SUPPLEMENTAL CORRECTION SHEET FOR THE BASELINE HILLSIDE ORDINANCE (BHO)

(Ordinance No. 184,802 Effective 3/17/17)

This is a supplemental correction sheet. Please see the attached master correction sheet.

Figure 12.21 C.10(a): Plane break diagram

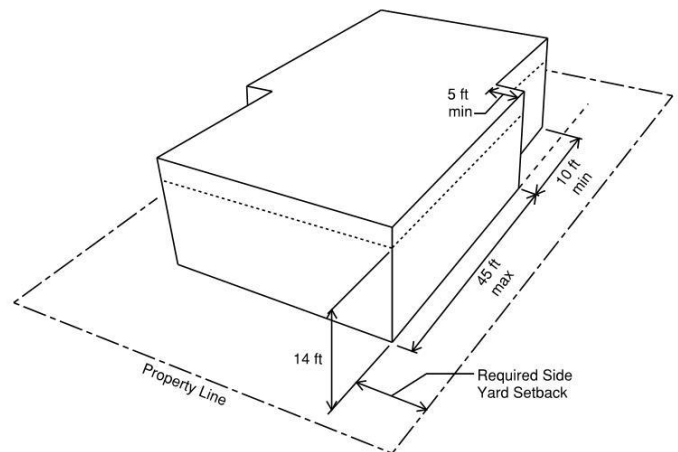
3. In the R1 zone, where the Building or Structure has a side wall that exceeds a height of 14 ft. and has a length of 45 ft. or more, provide an offset/plane break that has a minimum depth of 5 ft., beyond the required Side Yard setback, for a minimum length of 10 ft. (*Table 12.21C.10-1*). See below for Example Figure 12.21 C.10(a).
4. In the R1 zone, any occupied rooftop deck shall be set back at least 3 ft. from the minimum required Side Yard setback. This does not apply to any rooftop deck located on the street side of a corner lot. *12.21C.10(a)(7)*

Figure 12.03-1: Encroachment Plane diagram

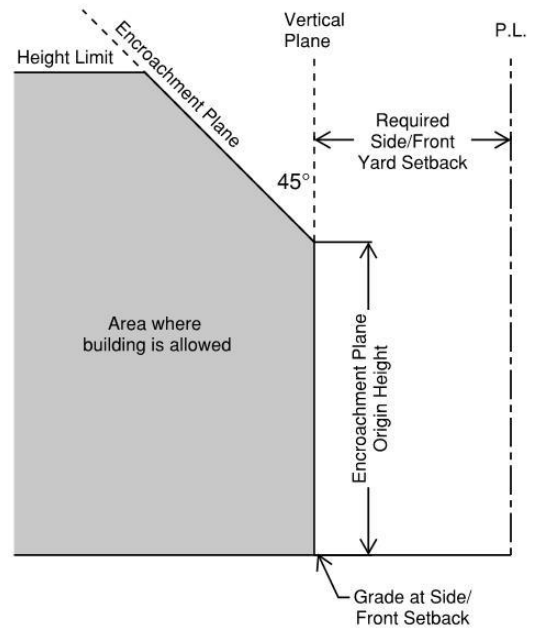
5. Show that all Buildings and Structures in the R1 zone do not exceed the Encroachment Plane Height with an Encroachment Plane Origin Height of 20 ft. and Encroachment Plane angle of 45° measured from existing or finished grade whichever is lower. See Figure 12.03-1 to the right.
